SUNDRY NOTICES AND REPORTS ON WELLS

8 Well Name and No
Skelly Unit # 950

9 API Well No
30-015-32437

**Skelly Unit 950
30-015-32437
Chevron U.S.A.
May 31, 2011
Conditions of Approval**

Skelly Unit 950 Wellbore Diagram

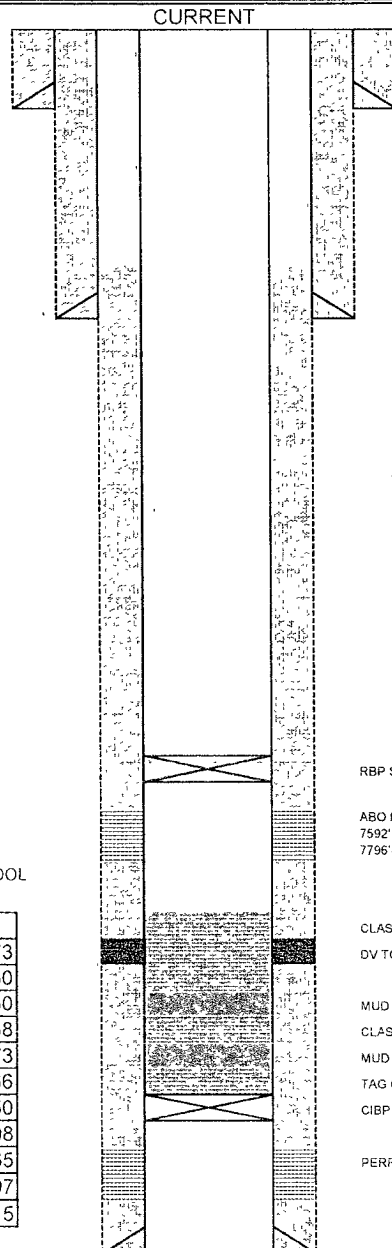
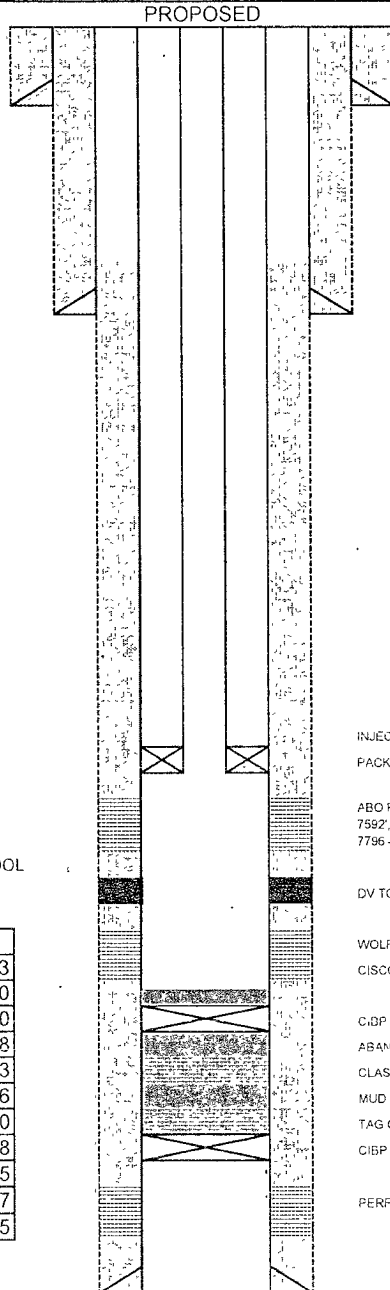
Chevron North America, respectfully requests administrative approval to inject salt water into the Skelly Unit well # 950, (API # 30-015-32437), located: 973' FNL & 2226' FWL, Unit Letter C, Section 28, T17S, R31E, Eddy County, New Mexico.

The injection interval will be in the Abo, Wolfcamp, and Cisco formation.

The proposed well procedure is as follows: MIRU PU. ND wellhead, NU BOP. TIH w/ retrieving head on 2 7/8" WS, wash sand off RBP set at 7417', latch onto RBP, un-set RBP, POOH, LD RBP. TIH w/ bit on 2 7/8" WS and clean out 25 sx cmt plug set from 8678' and tag top of cmt plug set from 11446'. Circulate abandonment fluid to 10000'. RU WL. RIH w/ CIBP and set at 10370'. Spot 25 sx class H cmt plug on CIBP through tubing. SDWOC 4+ hours. Tag plug. RU wireline and perf the following interval: 9362' - 9780'. The following interval is currently open: 7494' - 7848'. RIH w/ packer and RBP to treat in several stages w/ ball sealers. Acidize perfs from 7494' - 9780' w/10,000 gallons of 15% HCL acid. Displace w/FW. Release and TOH w/pkr. TIH w/ 3-1/2" injection tubing and pkr. Set pkr at 7450'. ND BOP. NU wellhead. Perform MIT. RDMO PU.

- 1. Notify BLM at 575-361-2822 a minimum of 24 hours prior to setting CIBP at 10370'.**
- 2. Surface disturbance beyond the originally approved pad must have prior approval.**

- 6. OPERATOR IS REQUIRED TO SUBMIT INFORMATION THAT NONE OF THESE FORMATIONS CAN PRODUCE IN PAYING QUANTITIES. THE BLM WILL REVIEW DATA SUBMITTED PRIOR TO INJECTION COMMENCING IN ANY OF THE PROPOSED ZONES. IF THE BLM CONCURS THAT THERE IS NO PRODUCTION EXISTING IN PAYING QUANTITIES, THE WELL WILL BE ALLOWED TO BECOME AN SWD IN THE ZONES REQUESTED. OPERATOR SHOULD NOTE THAT IN THE SECTION TO THE SOUTH, THERE IS A WELL PRODUCING FROM ESSENTIALLY THE SAME DEPTH AND CALLING THE FORMATION BONE SPRING. ALSO, TO THE NORTHWEST, THERE IS PRODUCTION FROM THE CISCO-CANYON AND WOLFCAMP FORMATIONS.**
